HISTORIC LANDMARK COMMISSION
APPLICATION FOR A CERTIFICATE OF APPROPRIATENESS
MARCH 22, 2021
C14H-2009-0021
YERWOOD-SIMOND HOUSE
2005 HAMILTON STREET

PROPOSAL

Installation of skylights on side and rear-facing roof slopes.

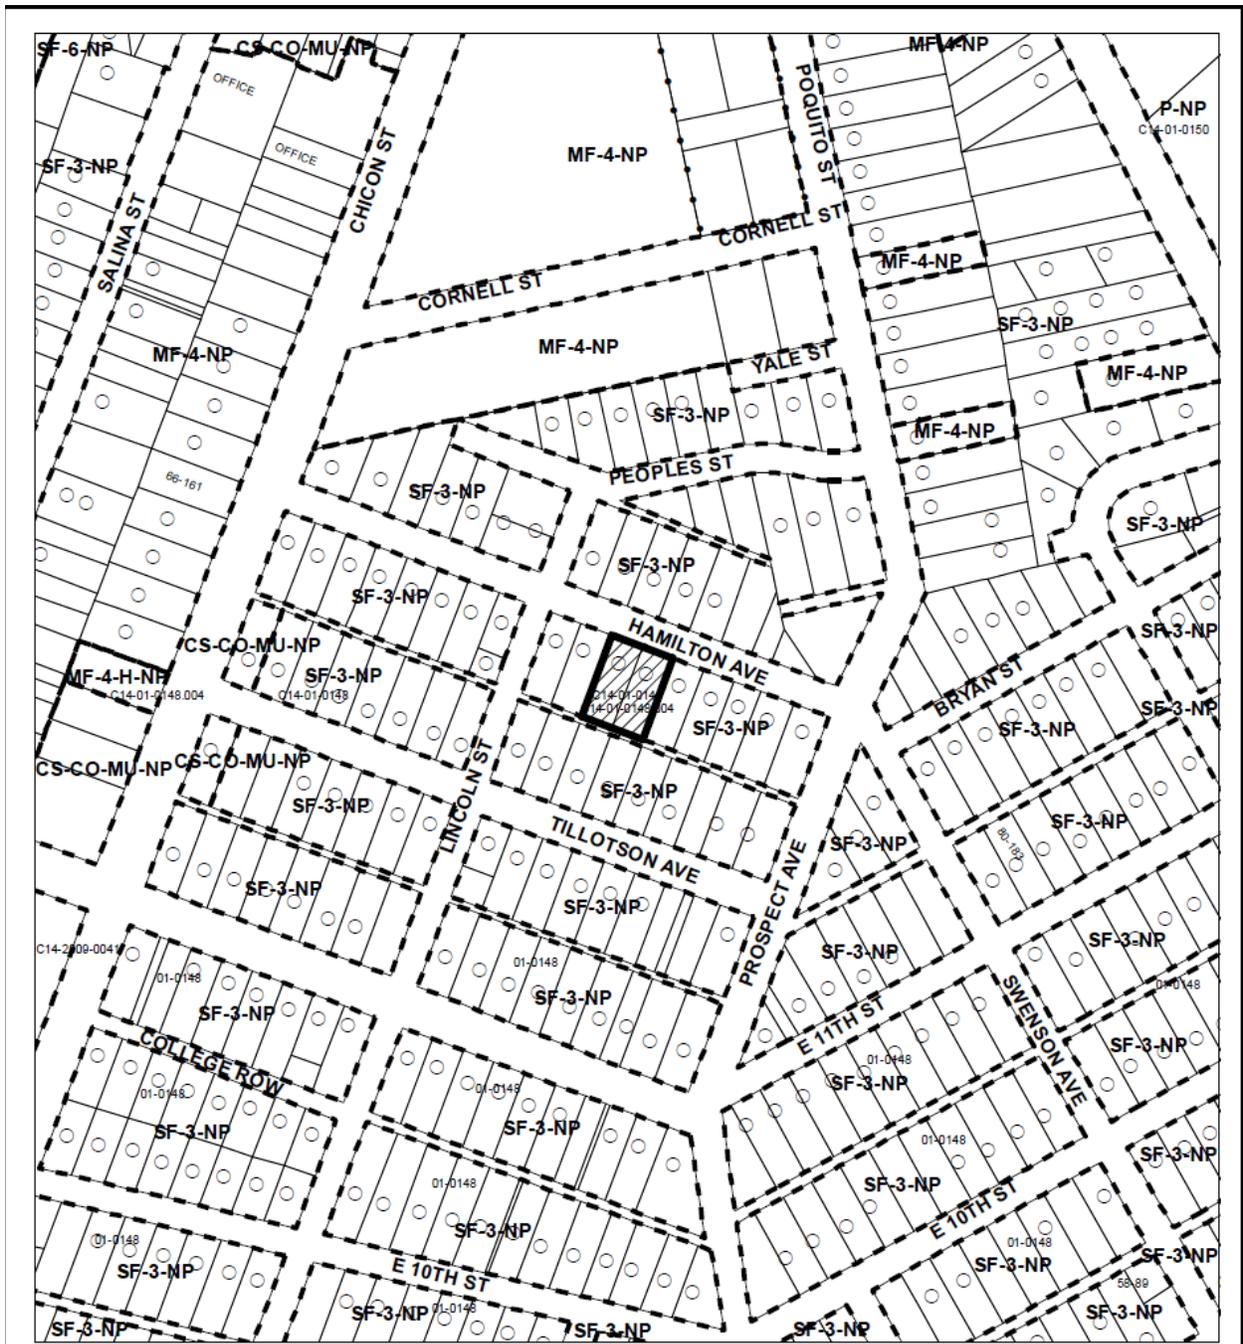
Evaluation: The proposed skylights add usable square footage to the house with minimal exterior intervention. The low profile, color selection, and placement to avoid the street-facing roof slope are compatible with and do not detract from character-defining features of the historic house.

The skylights' placement, low profile, and matching color are compatible with the house's roof. Committee members supported conditional administrative approval, pending review by the full Commission out of concern that the case could be precedent-setting.

Concur with Committee feedback and approve the application, while acknowledging this solution may not be appropriate for other landmarks.
